ADDENDUM NO. 2

South Putnam Middle School/High School Fieldhouse Addition

Project No. 222152.03

Date: June 20, 2024

“2.2.B. LOUVERS:

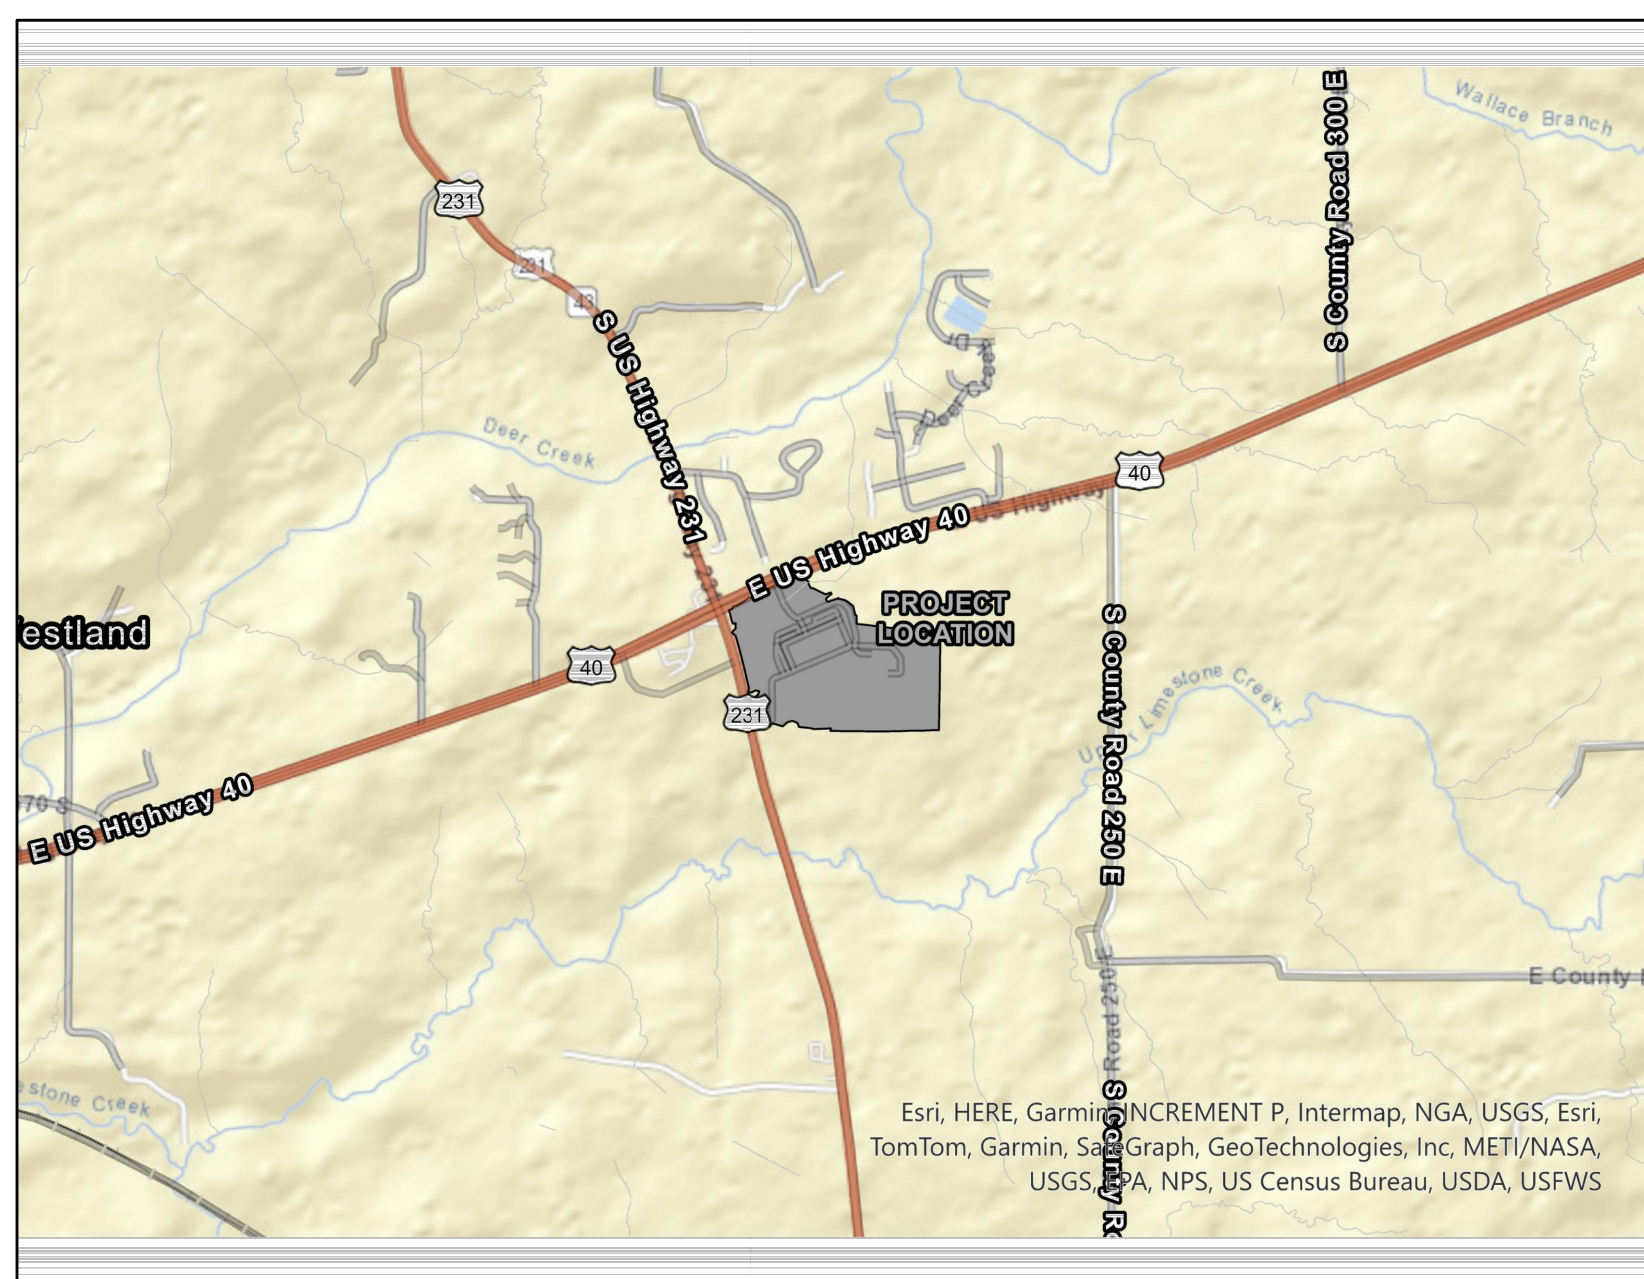
C. Add paragraph 2.2.B Louvers to read”

1. MANUFACTURERS: SUBJECT TO COMPLIANCE WITH REQUIREMENTS PER SCHEDULE ON DRAWING M601, PROVIDE PRODUCTS BY ONE OF THE FOLLOWING:
 - a. POTTORFF
 - b. GREENHECK
 - c. RUSKIN
 - d. AMERICAN WARMING AND VENT”
